ADDENDUM

ADDENDUM No. 3	GMCa JOB #: 202113 TDH
ISSUE DATE: 04.22.24	SBC #: 364/011-05-2021
PROJECT: Tennessee Tech University Derryberry Hall – Building Upgrades – Phase I	1 William L. Jones Drive Cookeville, TN 38505
OWNER: Tennessee Tech University	1 Bridgestone Park, 3 rd Floor Nashville, TN 37214
ARCHITECT: Gilbert McLaughlin Casella architects	2305 Kline Ave, Suite 200 Nashville, TN 37211

LIFE SAFETY EGRESS DIAGRAMS

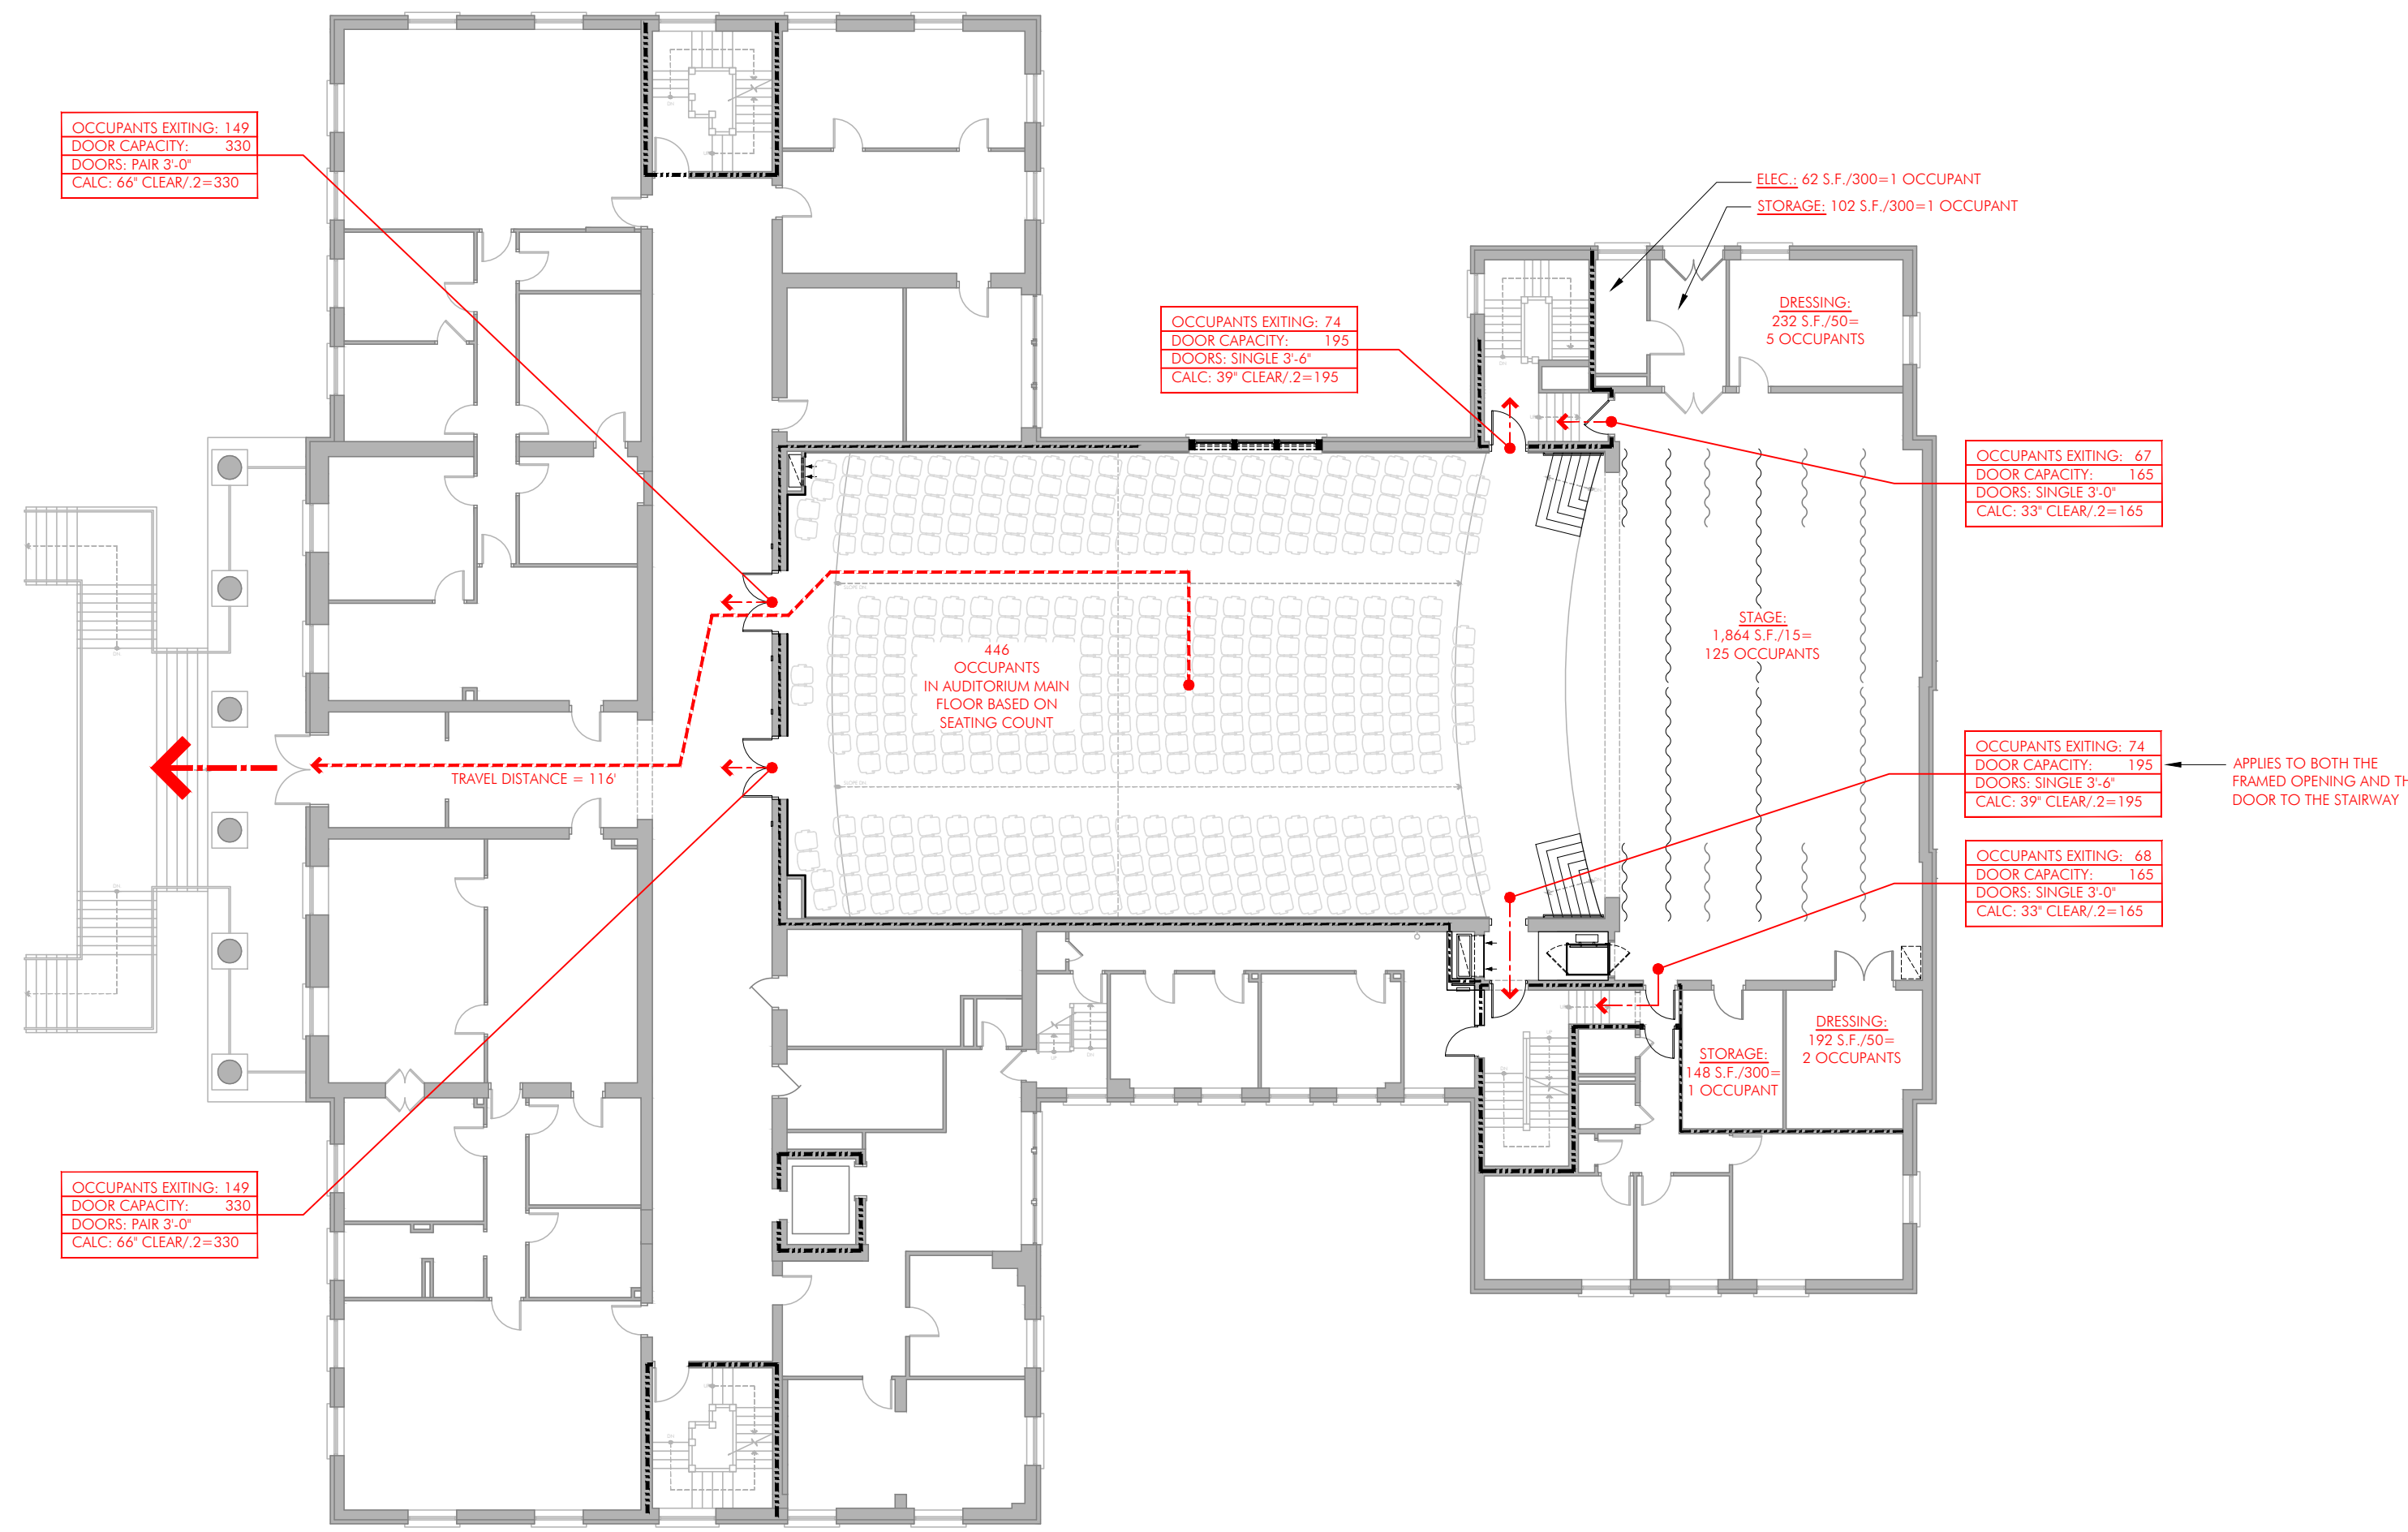
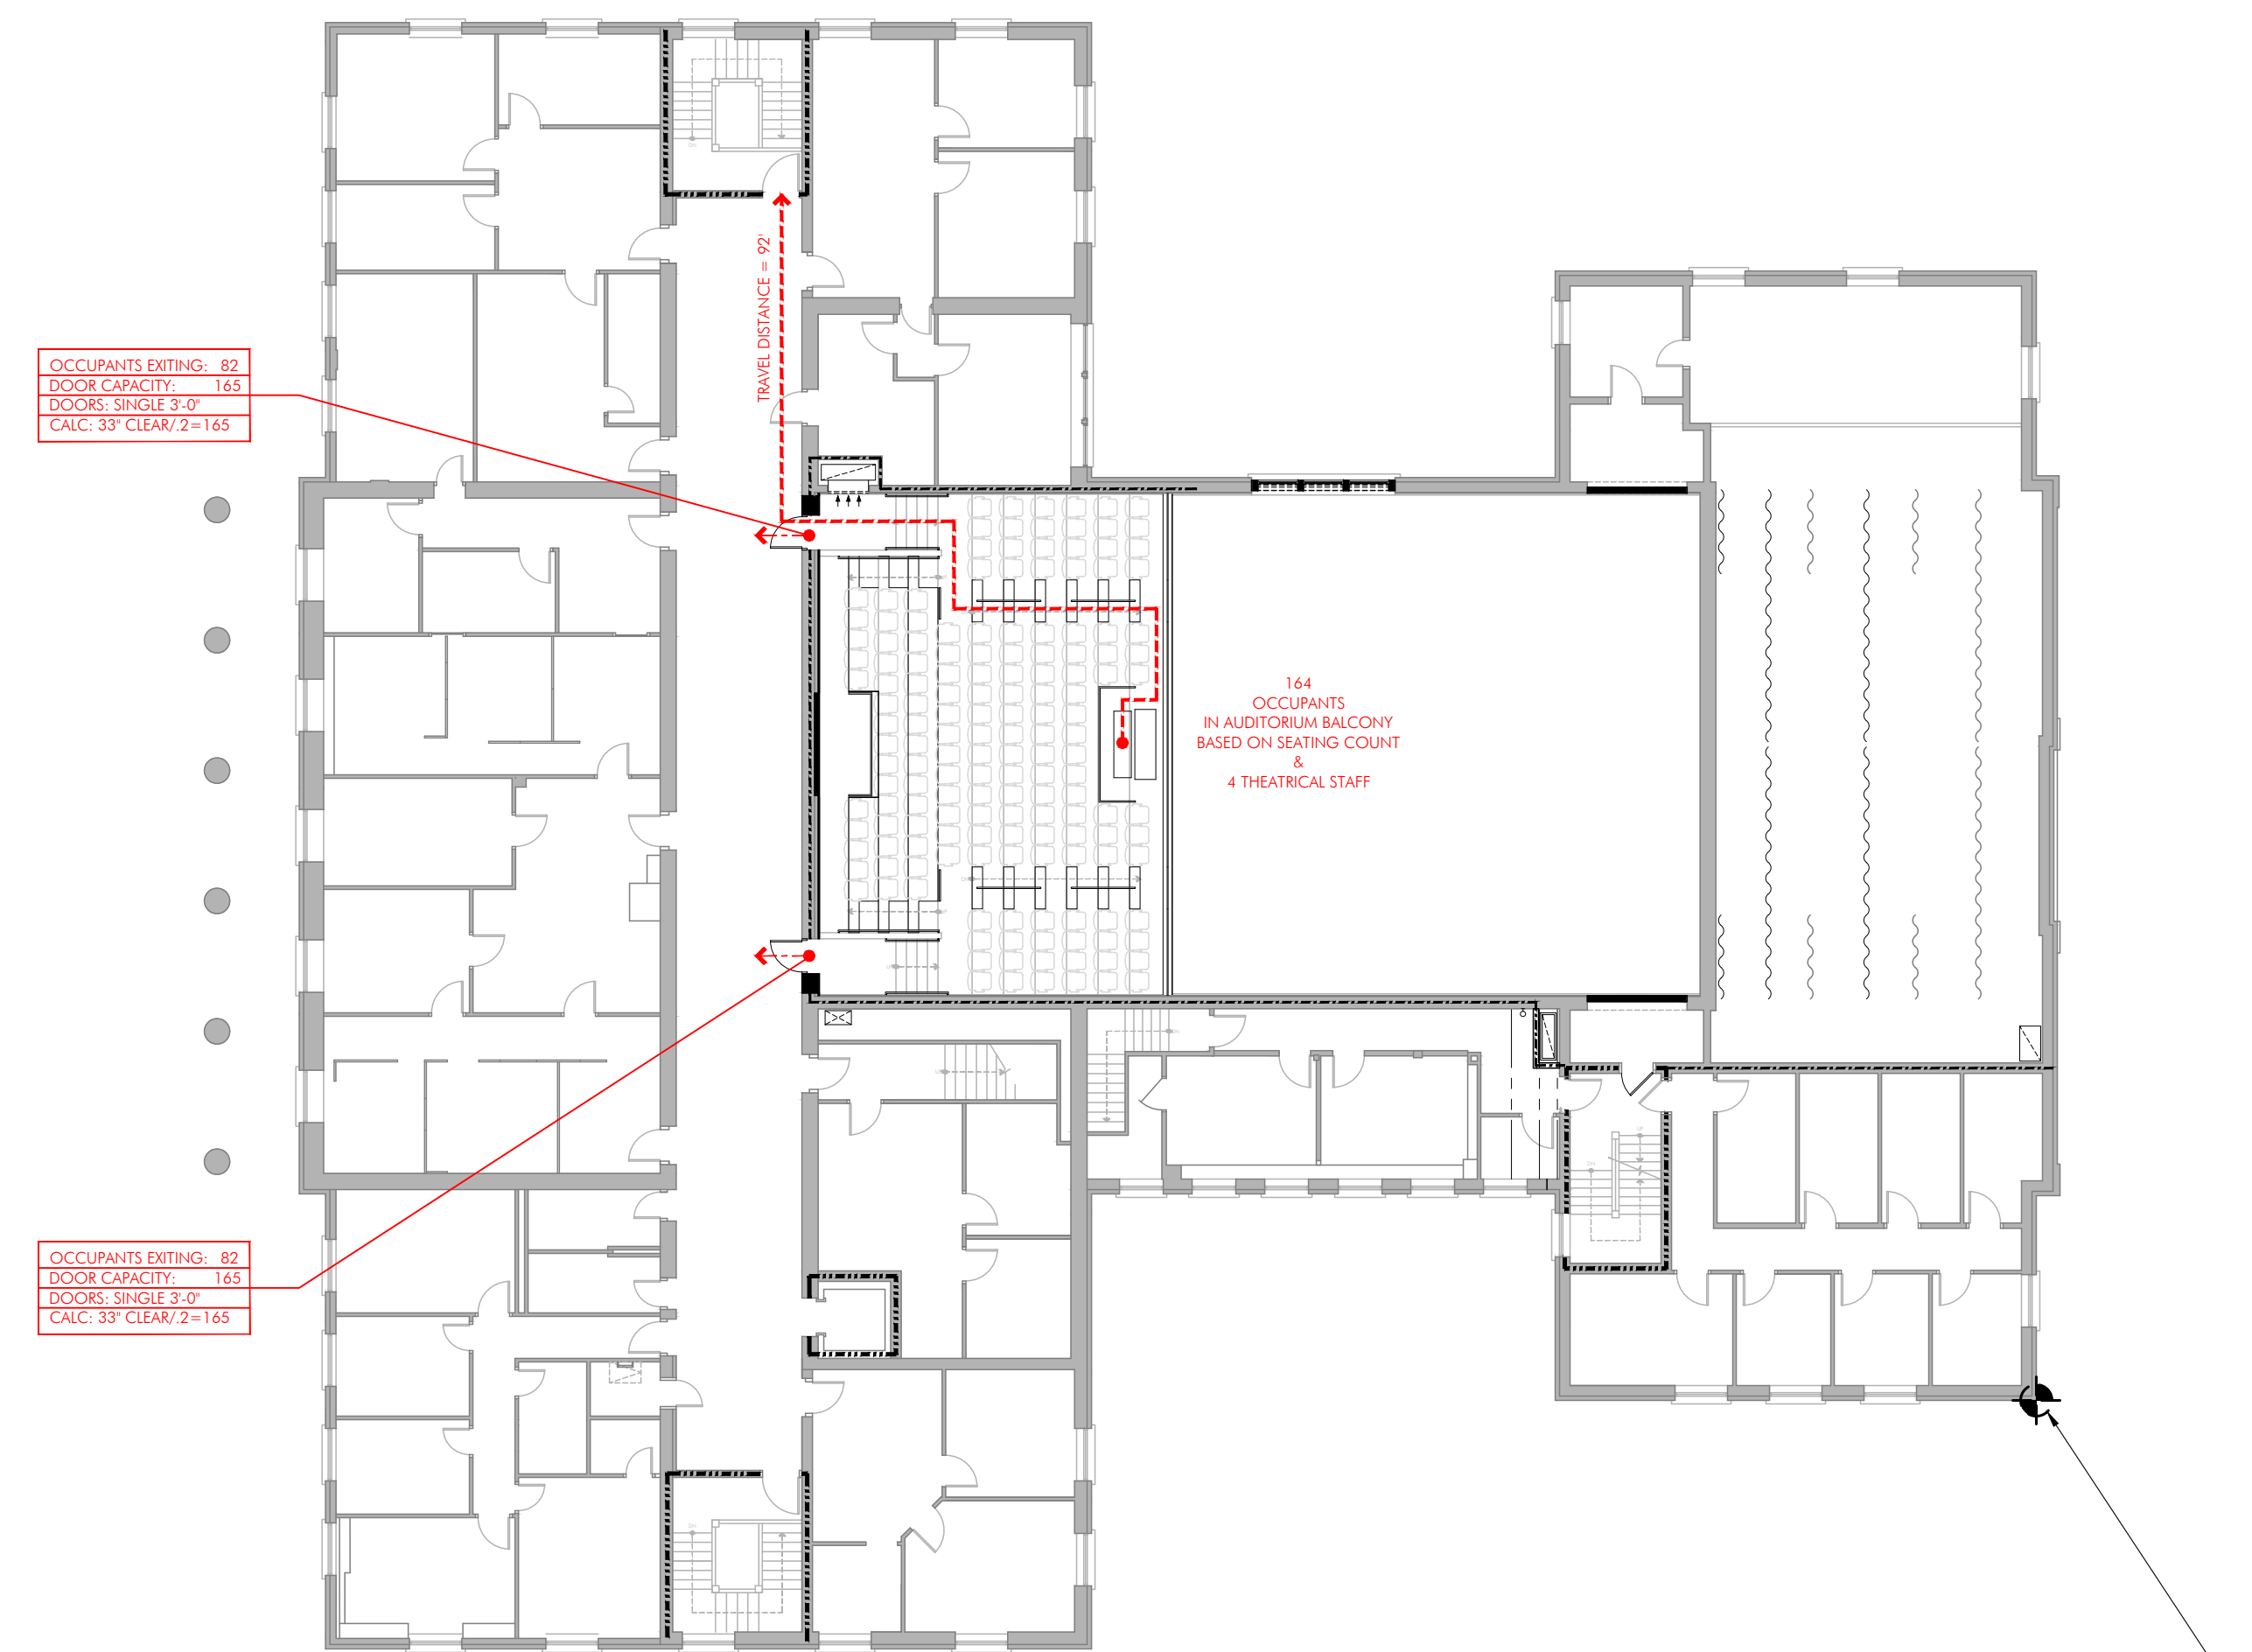
- 2) A0.1b – Life Safety Egress Diagrams (sheet added)
 - a) **Per SFM’s Comments:** Egress diagrams added
- 3) AD1.2 – Levels 3 & 4 – Enlarged Demolition Plans

DEMOLITION PLAN - LEVEL 3 & 4

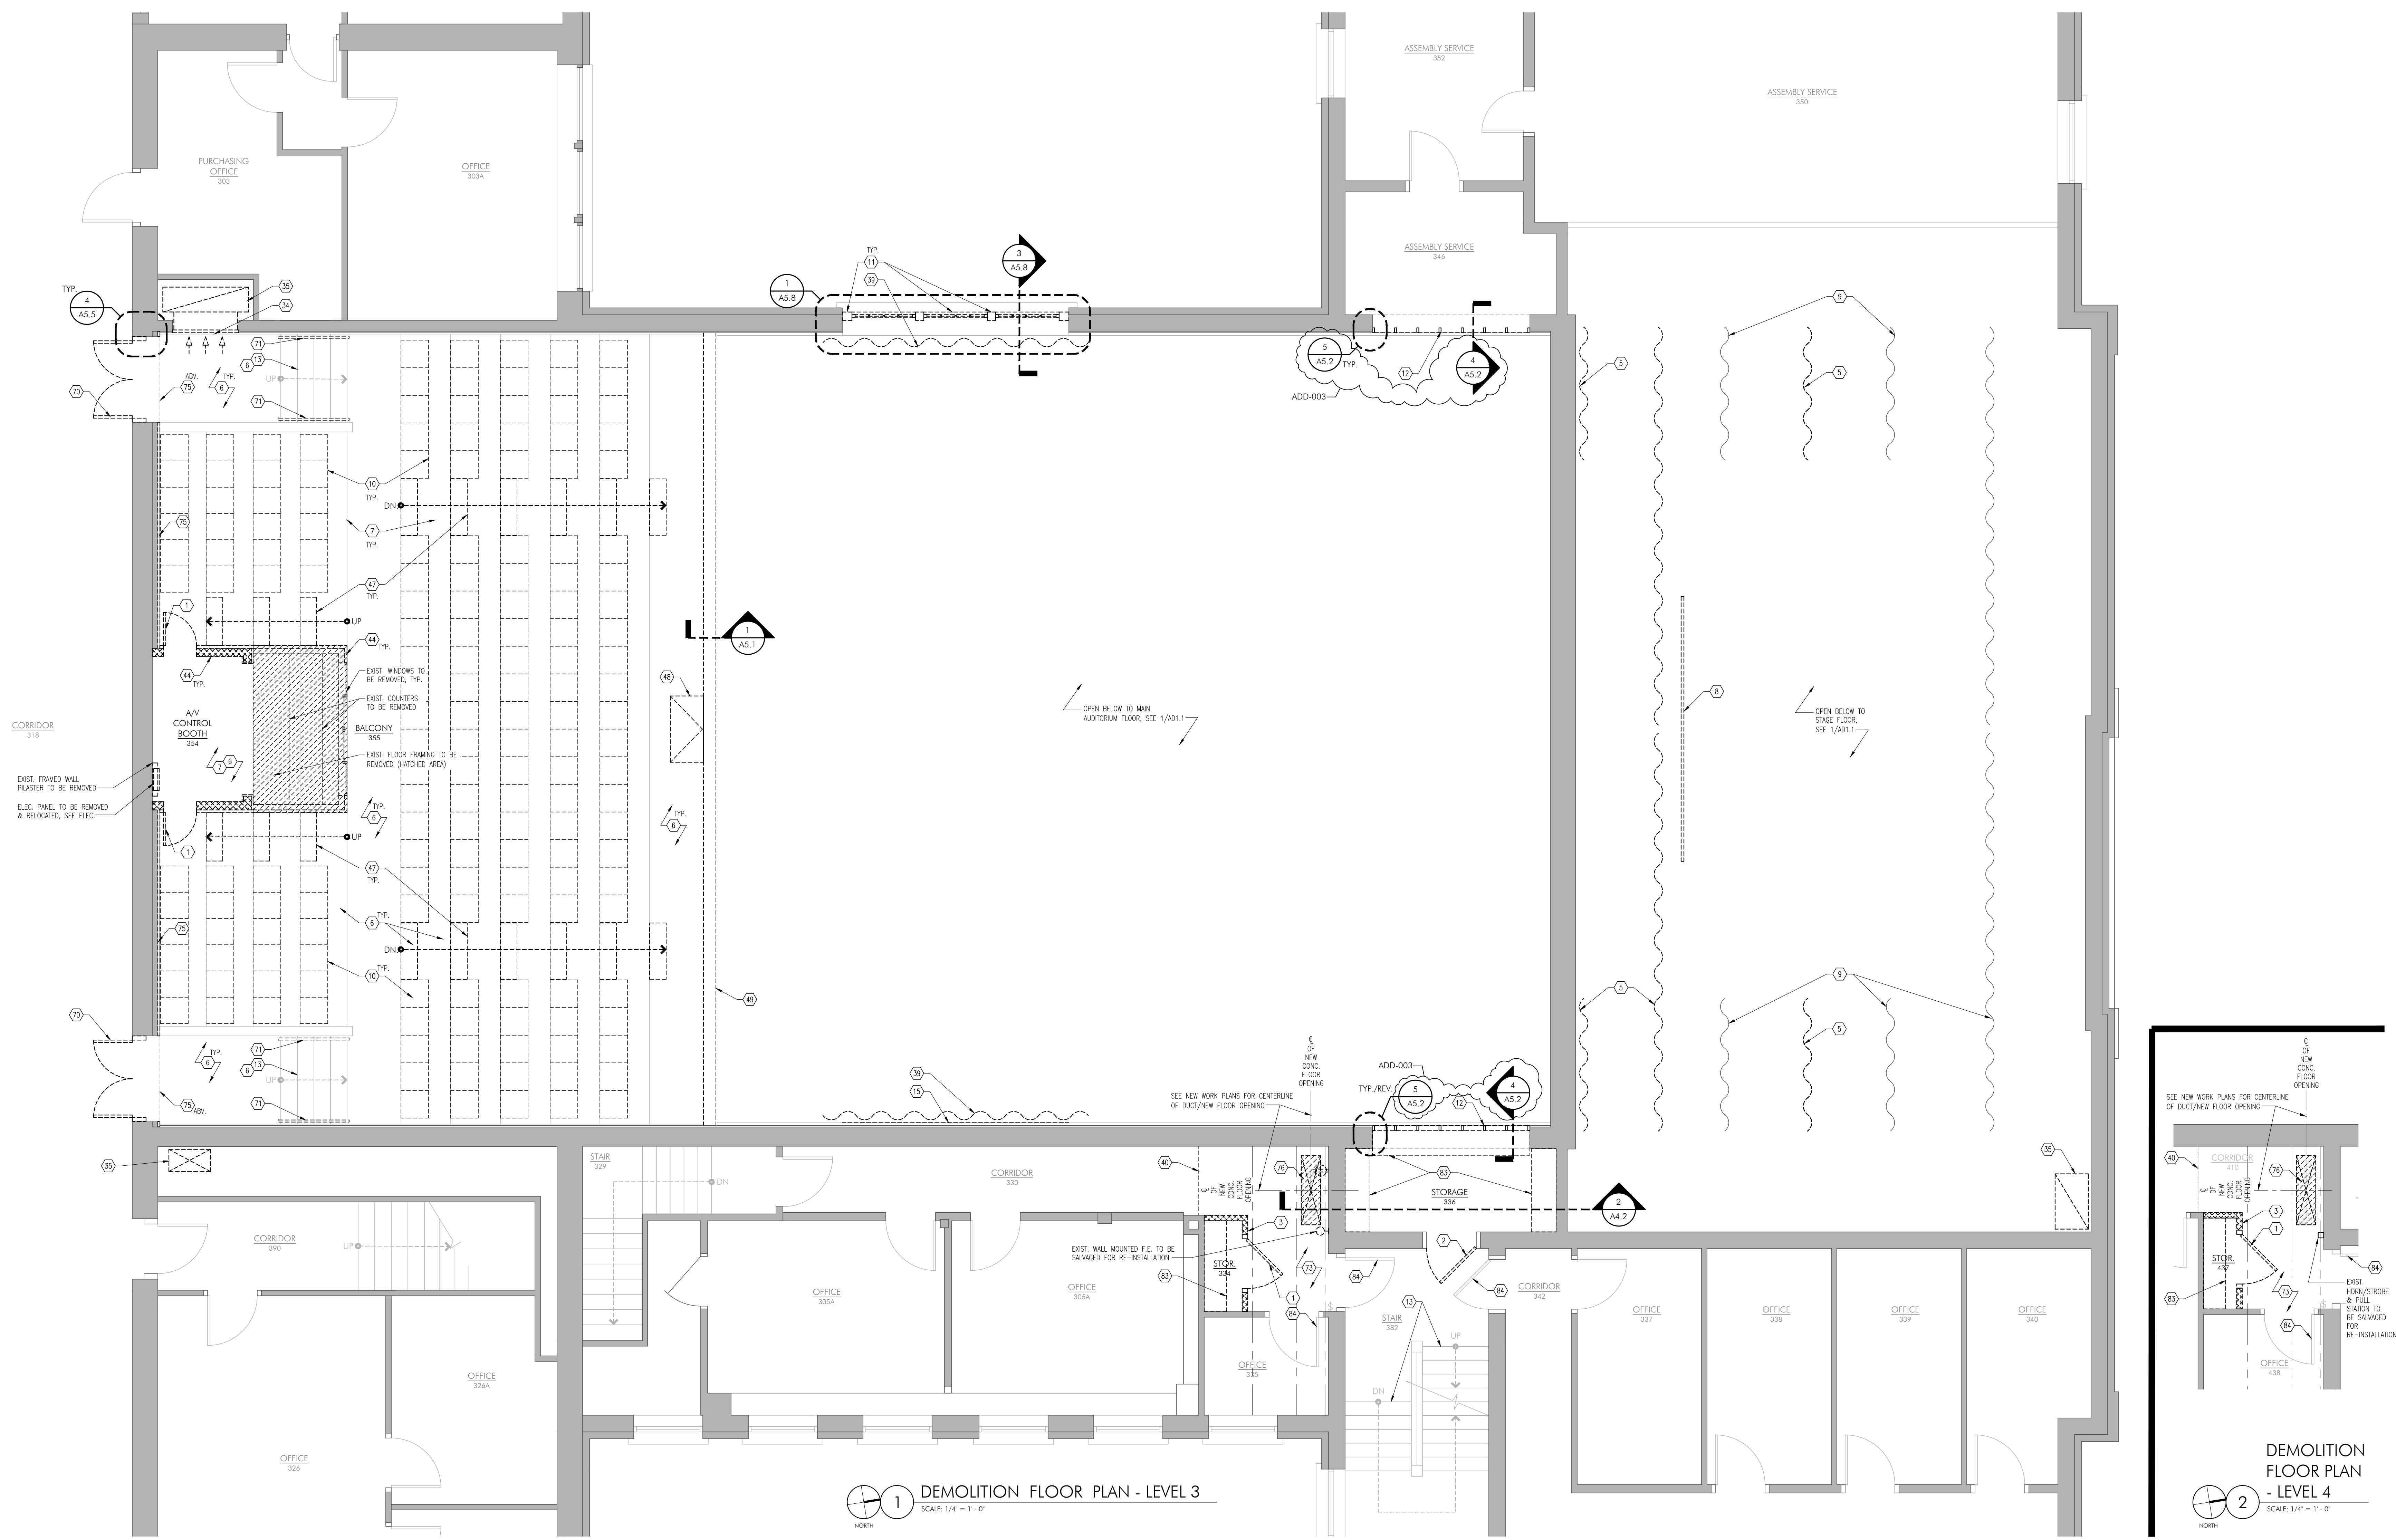
- a) **Per SFM’s Comments:** 4 detail marker references corrected
- 4) E2.2 - Electrical Lighting Plan - Level 2
 - a) **Per SFM Comments:** Added General Note E to call out required duration of emergency power systems.
